Access Compliance Report Public Rights-of-Way (Curb Ramps)

Main Street: S LAURINDA LN Cross Street: ROMELLE_AVE Location: NE

ADA ID: RPRK220222194810 Ramp Type: Type 1 - Perpendicular Diagonal Initial Pass/Fail: Fail Overall Compliance: No Severity Score: 16

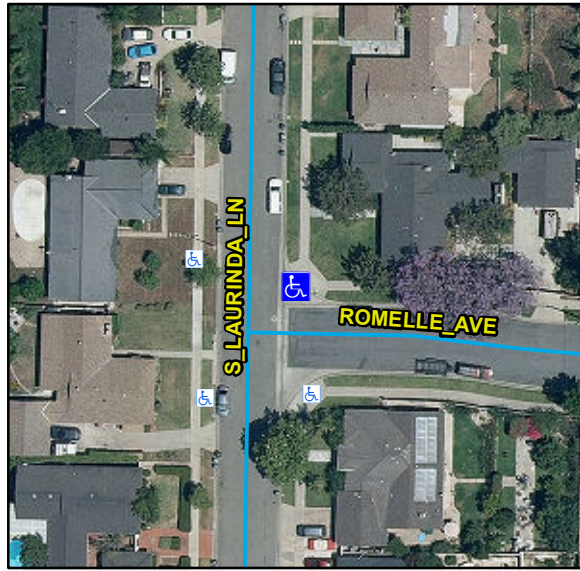
Compliance	Description	Data	Compliance	Description	Data
N/A	Ramp Length (in)	76	N/A	Flare Type LT	
Yes	Ramp Width (in)	48			N/A
No	Ramp Run Slope (%)	9.2	N/A	Flare Slope LT (%)	N/A
Yes	Ramp Cross Slope (%)	0.7	N/A	Flare Traversable LT	N/A
N/A	Landing Present	N/A	N/A	Flare Type RT	
N/A	Landing Length (in)	N/A			N/A
N/A	Landing Width (in)	N/A	N/A	Flare Slope RT (%)	N/A
N/A	Landing Run Slope (%)	N/A	N/A	Flare Traversable RT	N/A
N/A	Landing Cross Slope (%)	N/A	N/A	DWS Provided	N/A
N/A	Landing Movement Obstructed?	N/A	N/A	DWS Contrast	N/A
	Landing Movement Type	N/A	N/A	DWS Length (in)	N/A
N/A	Landing Shared	N/A	N/A	DWS Full Width	N/A
N/A	Clear Space	No	N/A	DWS Offset Left (in)	N/A
N/A	Clear Space To Crosswalk (in)	N/A	N/A	DWS Offset Right (in)	N/A
N/A	Marked Crosswalk 1	No	N/A	Marked Crosswalk 2	No
	Crossing 1 Direction	W		Crossing 2 Direction	S
	Marked Crosswalk 1 Width (in)	N/A		Marked Crosswalk 2 Width (in)	N/A

Remove & Replace Curb Ramp With Two New Directional Ramps or Equivalent.
